Z-34
(2017)

ZONING PLAN
FOR
BURNS LANE PROPERTY
COBB COUNTY, GEORGIA
LAND LOTS 226 & 250 - 19TH DISTRICT

PETITION NO: Z-34

ZONING COMMENTS:

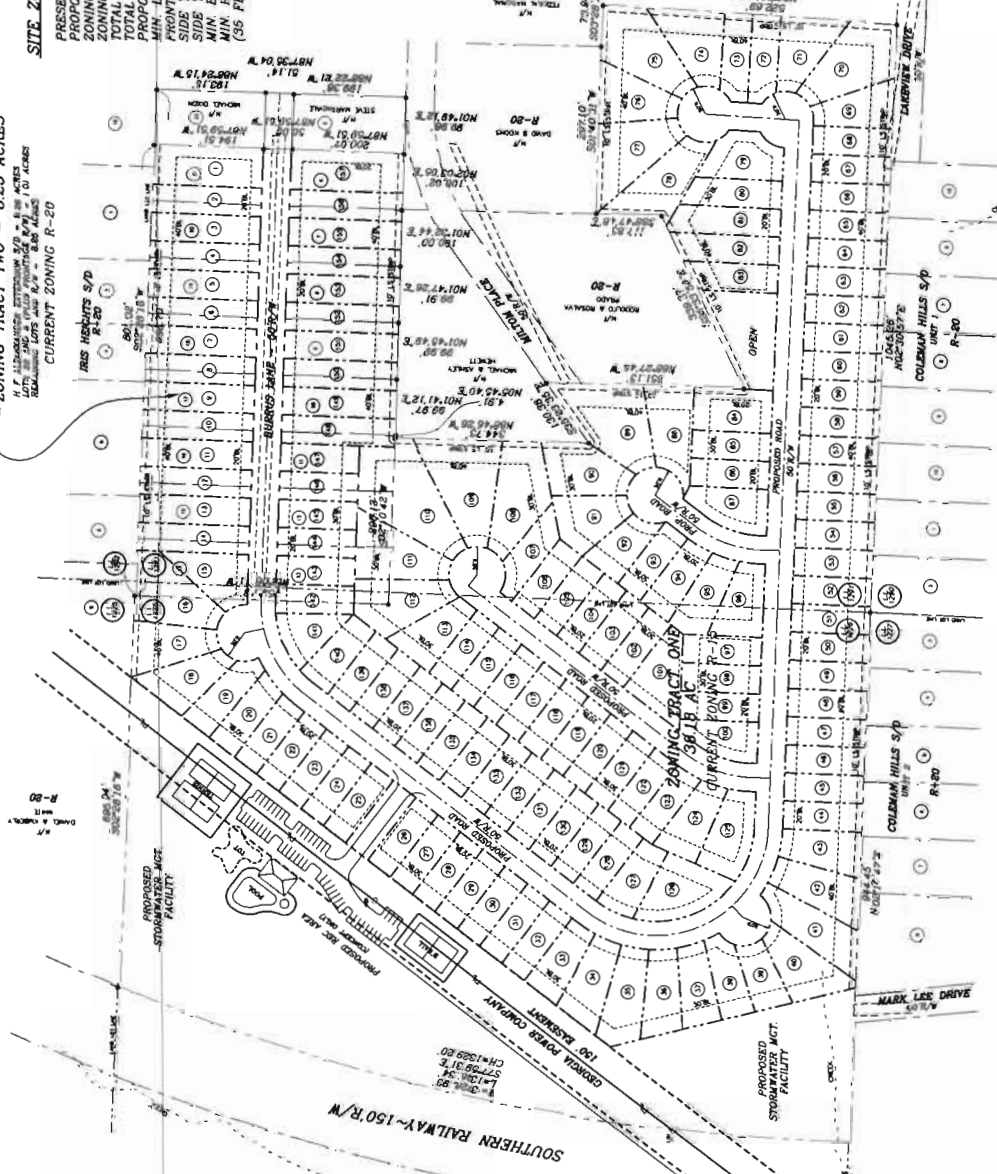
- Provide comprehensive hydrology/stormwater controls to include development of out parcels.
- Submit all proposed site improvements to Plan Review.
- Any **spring activity** uncovered must be addressed by a qualified geotechnical engineer (PE).
- Structural fill _____ must be placed under the direction of a qualified registered Georgia geotechnical engineer (PE).
- Existing facility.
- Project must comply with the Water Quality requirements of the CWA-NPDES-NPS Permit and County Water Quality Ordinance.
- Water Quality/Quantity contributions of the existing lake/pond on site must be continued as baseline conditions into proposed project.
- Calculate and provide % impervious of project site.
- Revisit design; reduce pavement area to reduce runoff and pollution.

3. Runoff from the upstream adjacent Iris Heights Subdivision to the east must be accommodated through the site. A drainage easement along the rear of lots 1 – 17 will likely be required.

4. Approximately 11.7 acres of the site currently drains into and through the Coleman Hills Subdivision to the west. This is an older subdivision that lacks adequate stormwater infrastructure to accommodate any increase in runoff volume. The applicant has agreed to significantly reduce the runoff discharged to #5489 Janet Lane and to convey all impervious runoff away from #5393 Janet Lane. This will likely require a drainage easement along the rear of lots 40 – 70.
